CITY OF ALBUQUERQUE

**RE: Target ABQ W
St. Josephs Drive – Lots 8A, 8-B, 8-C, 9-A, 9-C
Conceptual Grading and Drainage Plans
Engineer's Stamp Date: No Date
Hydrology File: G11D069F**

Based upon the information provided in your submittal received 12/20/2024, the Conceptual Grading & Drainage Plans are preliminary approved for Grading Permit and action by the Development Facilitation Team (DFT) on Site Plan for Building Permit.

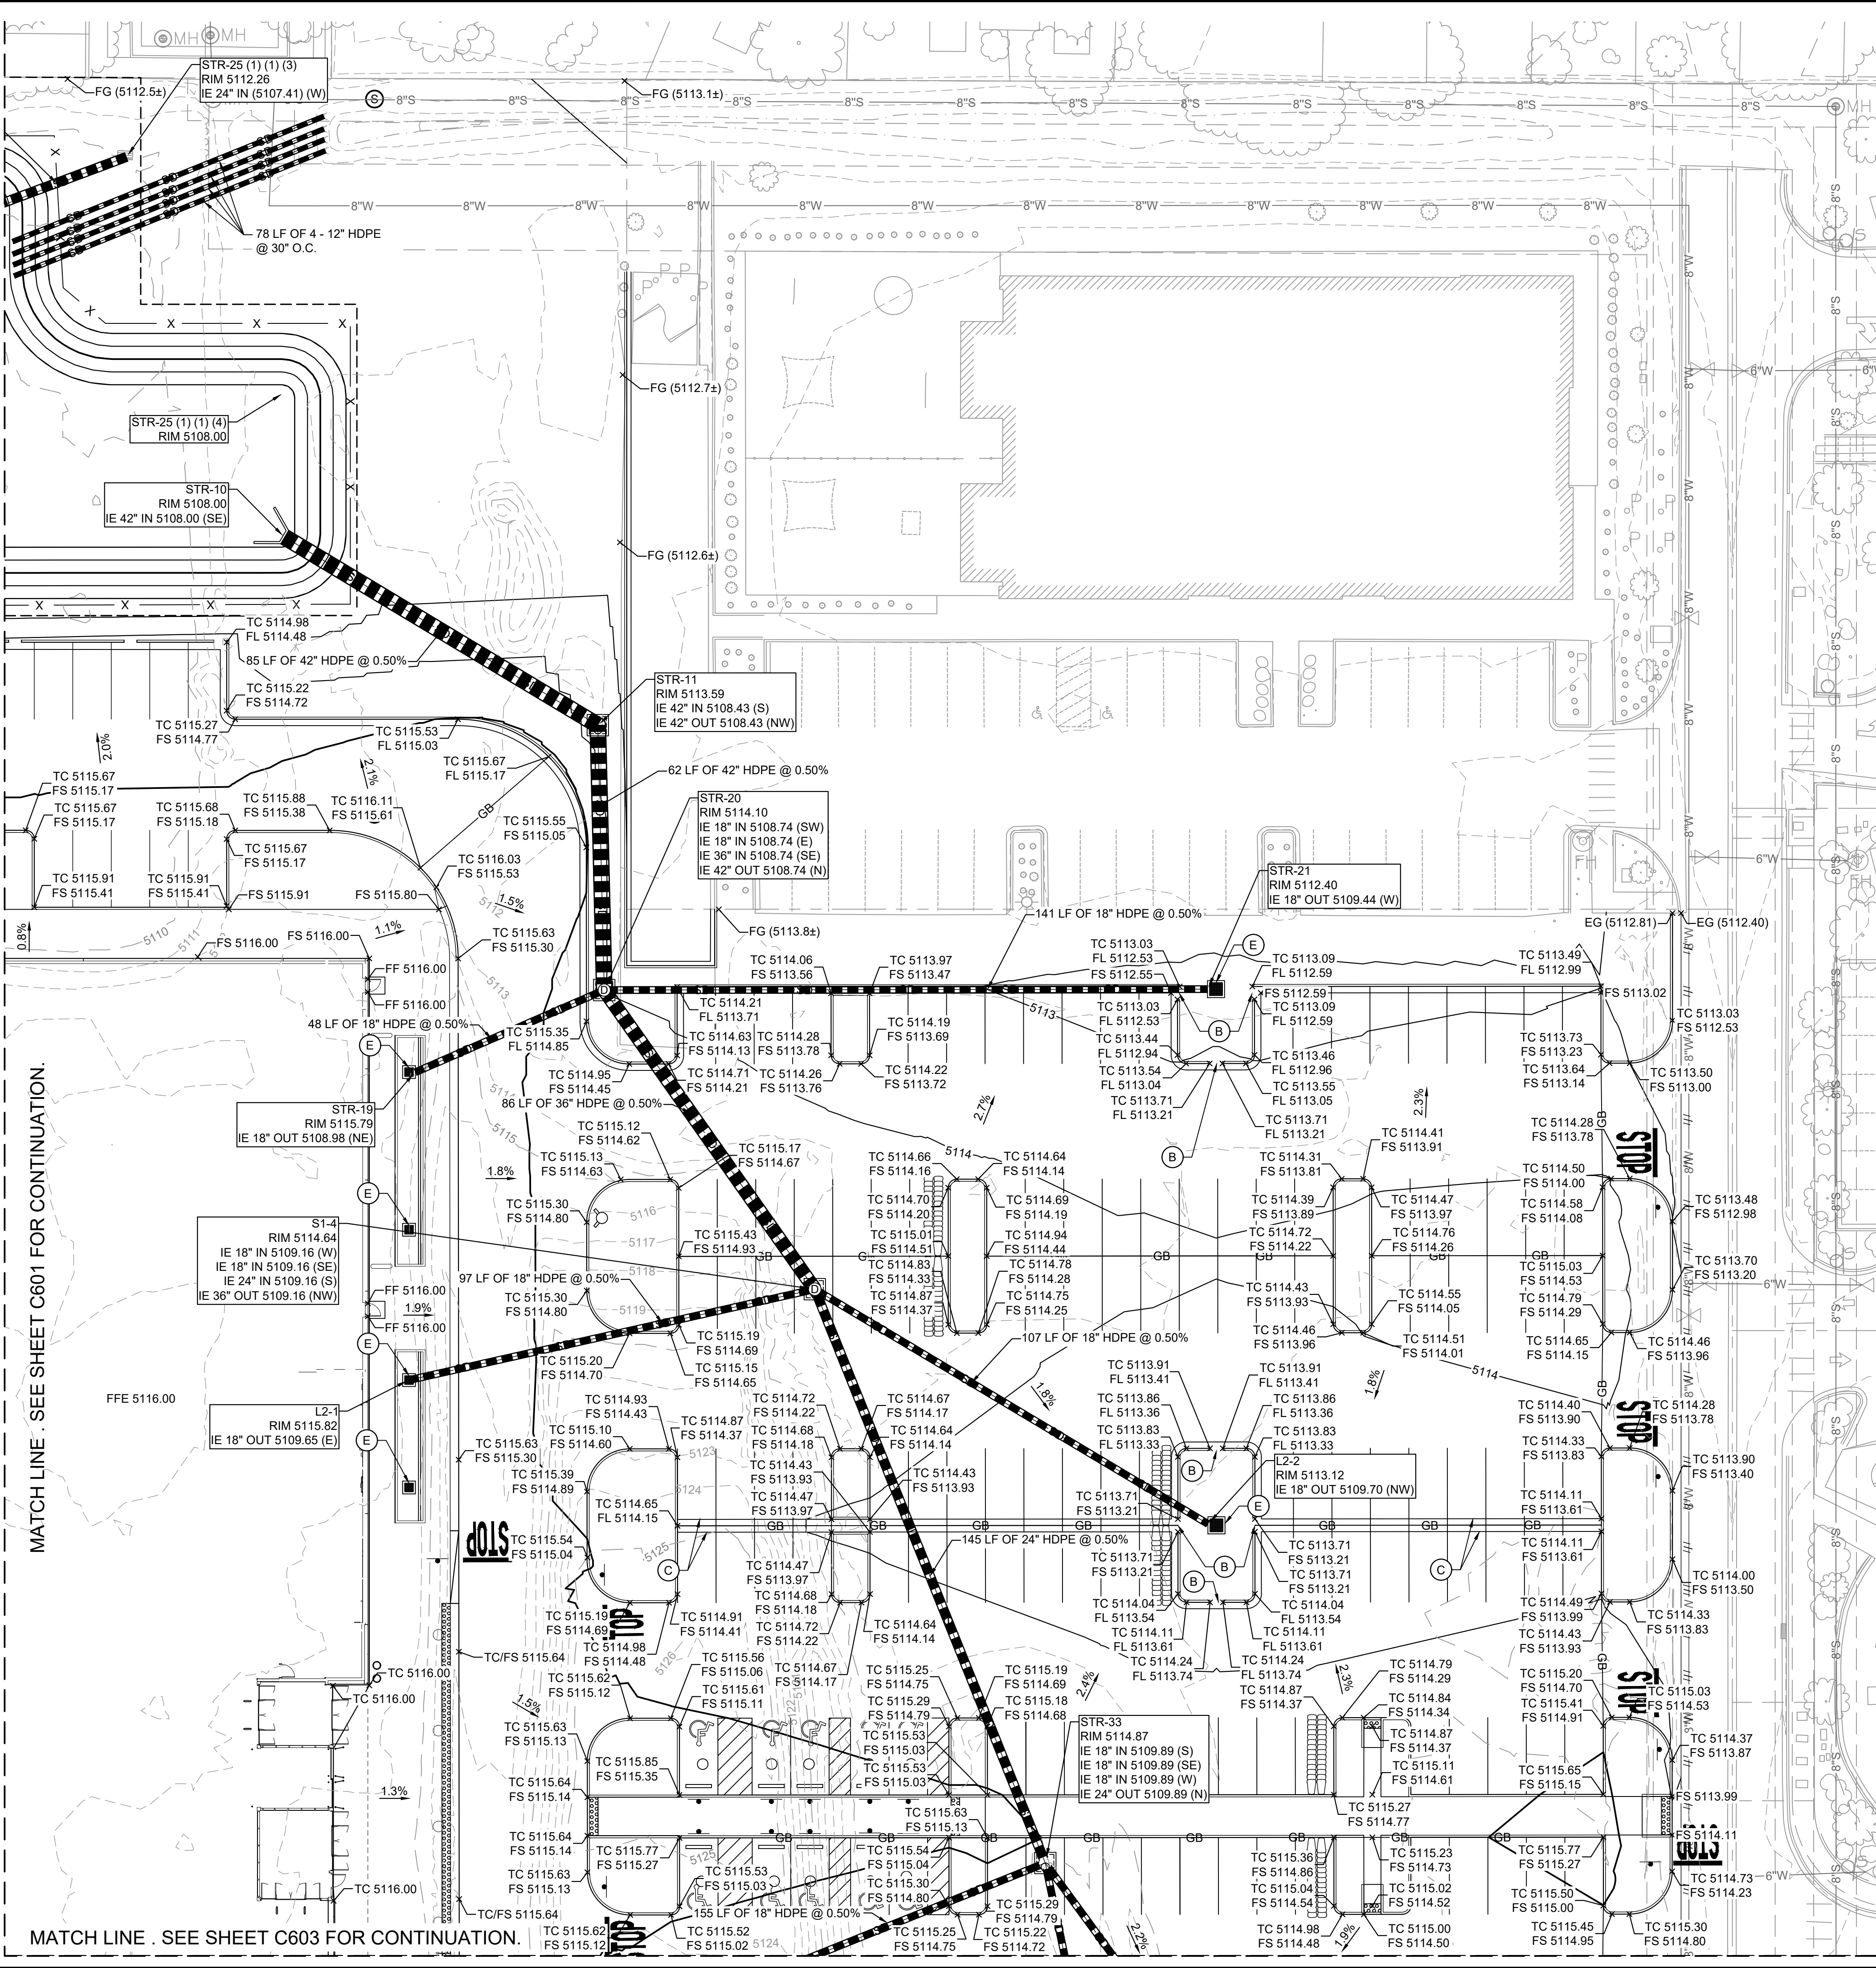
1. Please submit a more detailed Grading & Drainage Plan to Hydrology for review and approval. This digital (.pdf) is emailed to PLNDRS@cabq.gov along with the Drainage Transportation Information Sheet.
